ST. LUCIE PLANT UNIT NO. 1

Amendment No. 71
License No. DPR-67

ATTACHMENT TO LICENSE AMENDMENT NO. 71
TO FACILITY OPERATING LICENSE NO. DPR-67
DOCKET NO. 50-335

SAFETY EVALUATION BY THE OFFICE OF NUCLEAR REACTOR REGULATION

Figure 3.1-1a Allowable Time to Realign CEA vs. Initial F_T

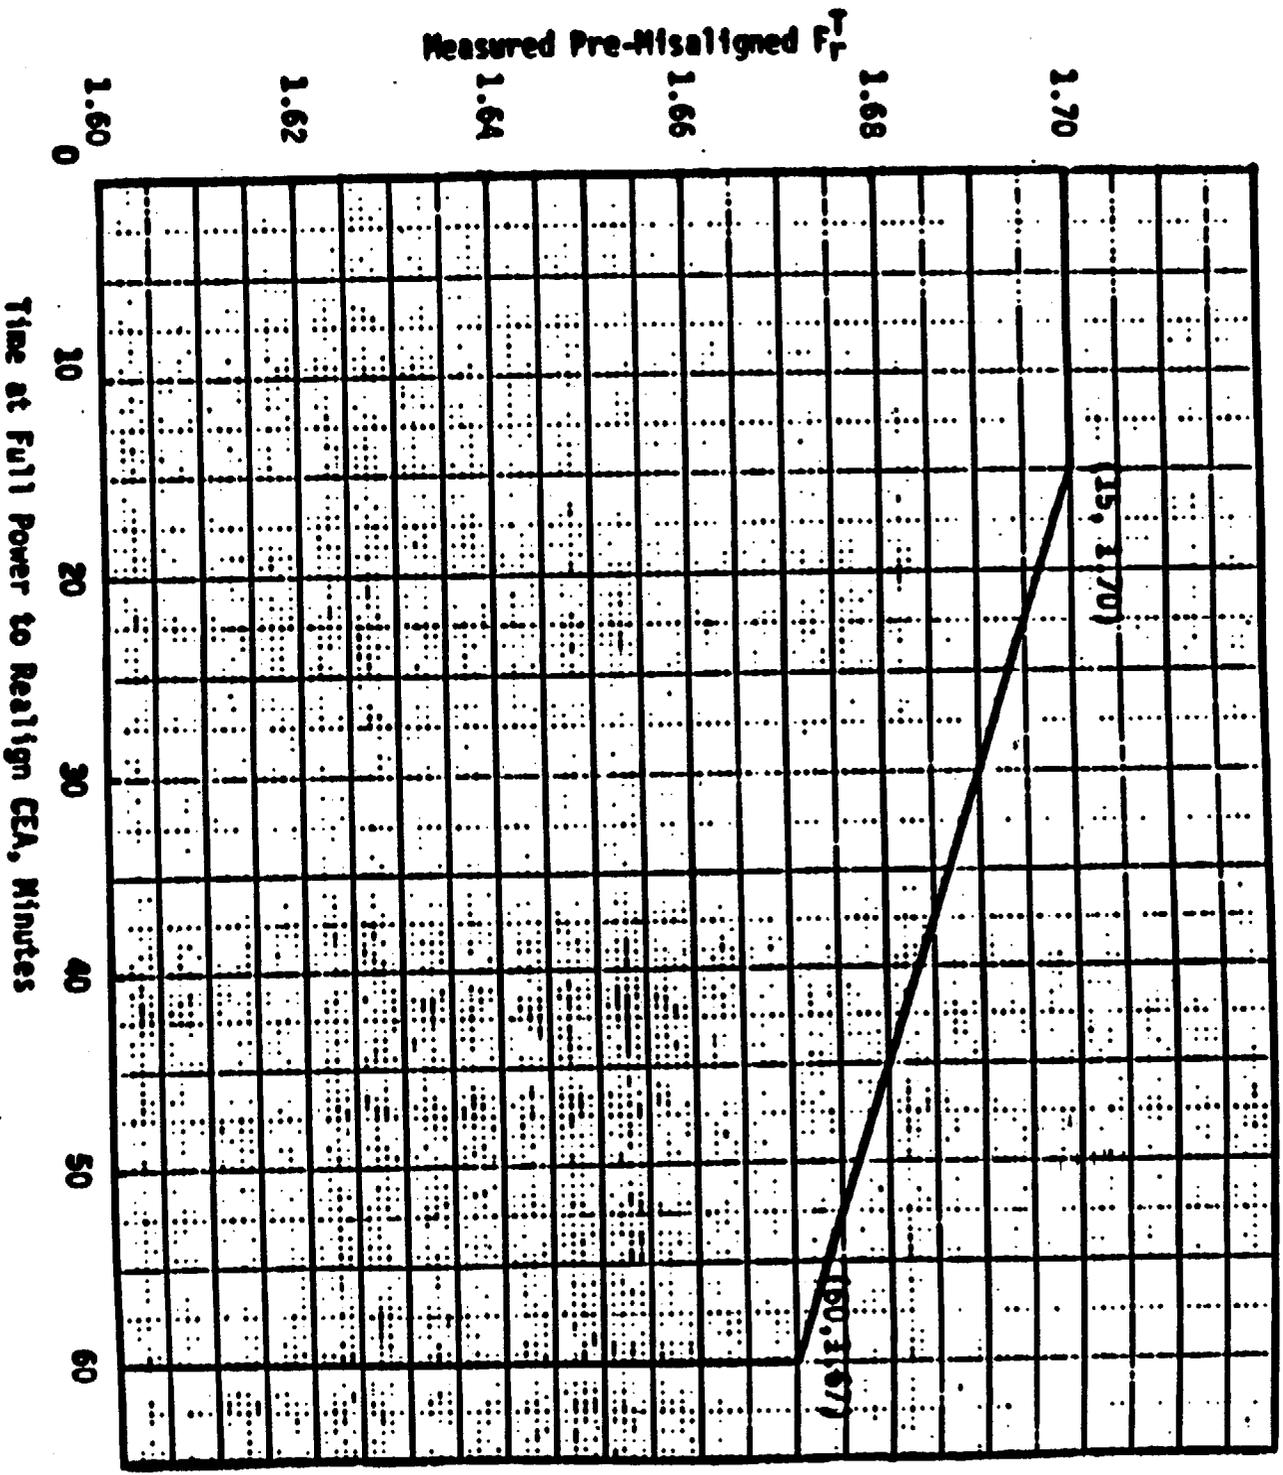
The requirement to reduce power in certain time limits, depending upon the previous F_r^t , is to eliminate a potential nonconservatism for situations when a CEA has been declared inoperable. A worst case analysis has shown that a DNBR SAFDL violation may occur during the second hour after the CEA misalignment if this requirement is not met. This potential DNBR SAFDL violation is eliminated by limiting the time operation is permitted at FULL POWER before power reductions are required. These reductions will be necessary once the deviated CEA has been declared inoperable. The time allowed to continue operation at a reduced power level can be permitted for the following reasons:

1. The margin calculations that support the Technical Specifications are based on a steady-state radial peak of $F_r^t > 1.70$.
2. When the actual $F_r^t \leq 1.70$, significant additional margin exists.
3. This additional margin can be credited to offset the increase in F_r^t with time that can occur following a CEA misalignment.
4. This increase in F_r^t is caused by xenon redistribution.
5. The present analysis can support allowing a misalignment to exist for up to 60 minutes without correction, if the initial $F_r^t \leq 1.67$.

The licensee has proposed to incorporate the attached Figure 3.1-1a into the St. Lucie 1 Technical Specifications showing the allowable time to realign a dropped CEA as a function of the initial value of F_p . The figure permits only 15 minutes of full power operation when the pre-drop value of F_p equals 1.70 even though the analyses show that at least 1 hour would be permissible. As the pre-drop value of F_p decreases to 1.67, operation at full power for up to 1 hour is allowed. Based on the CEA drop analyses mentioned previously, the staff finds this acceptable.

- e. With one full length CEA misaligned from any other CEA in its group by 15 or more inches, operation in MODES 1 and 2 may continue provided that the misaligned CEA is positioned within 7.5 inches of other CEAs in its group in accordance with the time constraints shown in Figure 3.1-1a.

- f. With one full-length CEA misaligned from any other CEA in its group by 15 or more inches beyond the time constraints shown in Figure 3.1-1a, reduce power to \leq 70% of RATED THERMAL POWER prior to completing ACTION f.1 or f.2.
